Attachment 1 - PLN19/0751 - 375 & 377 Punt Road - Advertised Plans Part 1

PROPOSED HOTEL DEVELOPMENT AT 375-377 PUNT RD RICHMOND

**TO:** Laura Condon, Senior Statutory Planner  
**FROM:** Julia Bennett-Mitrovski, Senior Planner (Community Health and Safety)  
**DATE:** 29 January 2020  
**ADDRESS:** 375 Punt Road, Richmond  
**APPLICATION NO:** PLN19/0751  
**DESCRIPTION:** Development of the land within the existing building (internal and external alterations) and use as a residential hotel (61 rooms), food and drink premises and bars:

**Figure 2: Roof terrace**

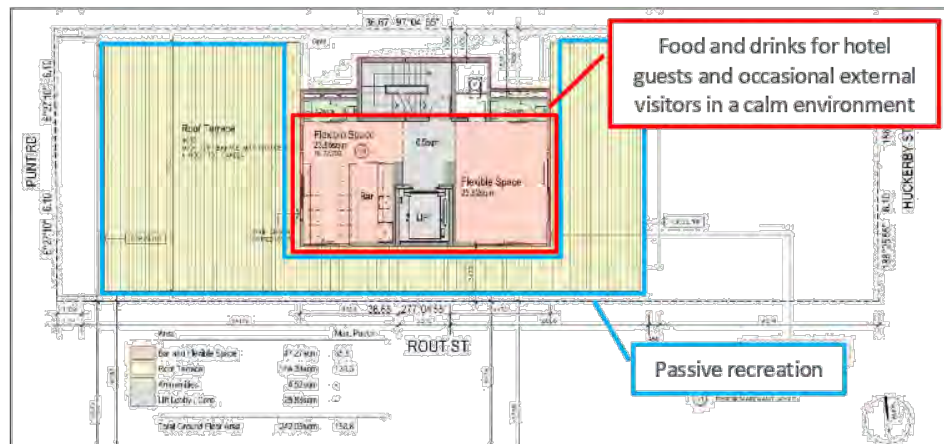
The current red line plan does not allow for alcohol consumption in the open air roof terrace area. For noise assessment purposes it has been assumed that the open air area may be used by hotel guests for passive recreation, eg, book reading or sunbaking or may be used by smokers.

Figure 4: Roof level plan

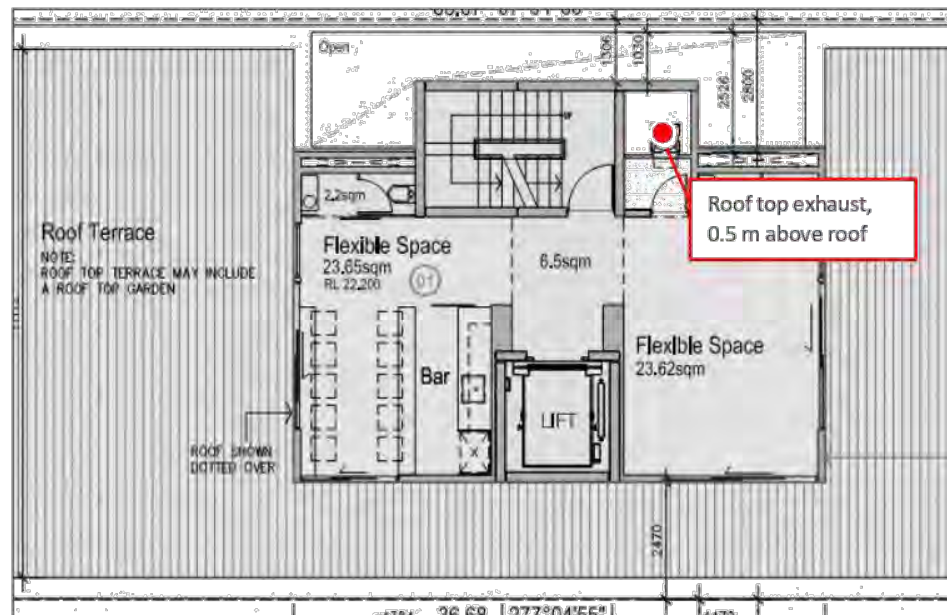
MDA provides the following guidance for the mechanical services engineer to assist with equipment selection based on mechanical services duct terminations and ventilation louvers as indicated in Figure 4 and Figure 5. Additional mechanical plant items may be included provided their noise level and cumulative impact is assessed when sufficient detail is available.

Location	Maximum sound power level at opening
Roof top exhaust	97 dB
Compressor/condenser ventilation louvre	90 $L_w/m^2$ dB

Figure 6: Roof top bar

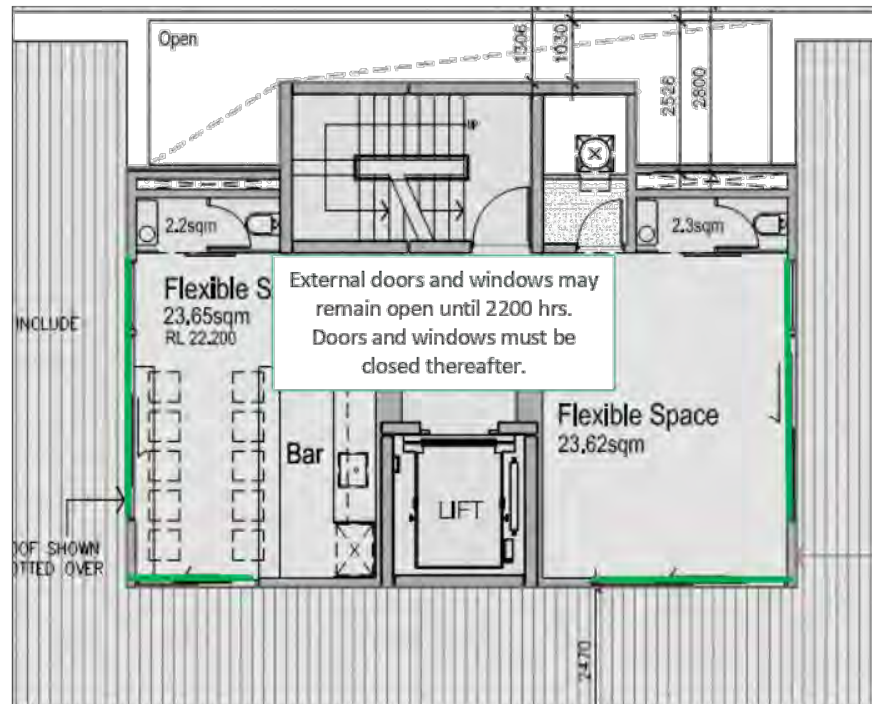
- Music should be restricted to background music noise levels per Table 17 in Section 9.1. Should the operator wish to incorporate amplified or live music of any kind a specific acoustic assessment shall be required prior to commencement of such operations
- During the day-time and evening periods (0700 hrs to 2200 hrs) external doors and windows may be open
- During the night-time period (2200 hrs until closing at midnight) all external windows and doors must remain closed
- The requirement for bar staff to proactively monitor the behaviour of bar patrons should be included in the management plan.

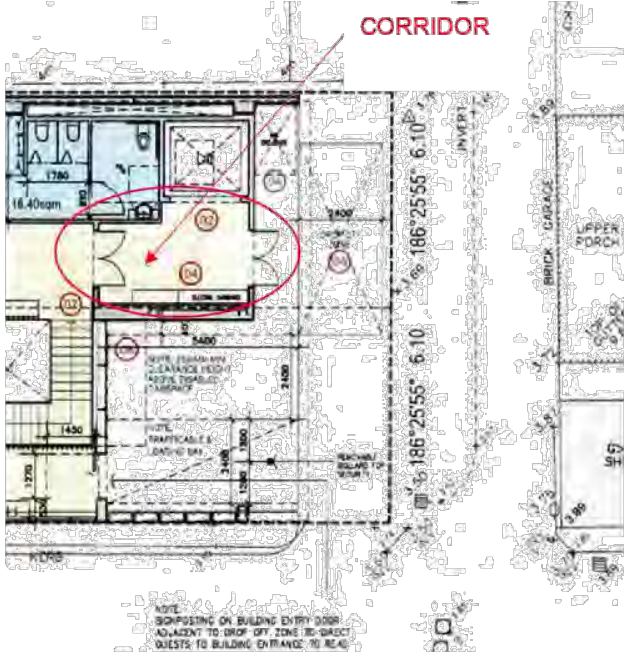
Item	Details
Headroom Clearance	The headroom clearance at the entrance to the car spaces is to be dimensioned on the drawings.

Accessible Car Space	Should an accessible car space be provided, an adjacent shared area is to be installed to satisfy AS/NZS 2890.6:2009.
Drop-off Zone	The length of the drop-off zone is to be dimensioned on the drawings.
Clearances to Walls	The clearance to the wall of the car space nearest to Rout Street is to be dimensioned on the drawings.
Vehicle Turning Movements	Swept path diagrams for a B99 design vehicle demonstrating satisfactory access into and out of the car spaces is to be provided.
Loading Bay	The provision of the loading bay is subject to the removal of the accessible car space.
Waste Collection Vehicle	The height of the refuse collection truck to be used for this development is to be provided to ensure that it can access the loading bay.
Bicycle Considerations	The bicycle requirements for this development are to be referred to Council's Strategic Transport unit for assessment.
Internal Concrete Slab	For any internal concrete works, the finished floor levels along the edge of the slab must be set 40 mm above the edge of Huckerby Street/Rout Street – Council Infrastructure requirement.
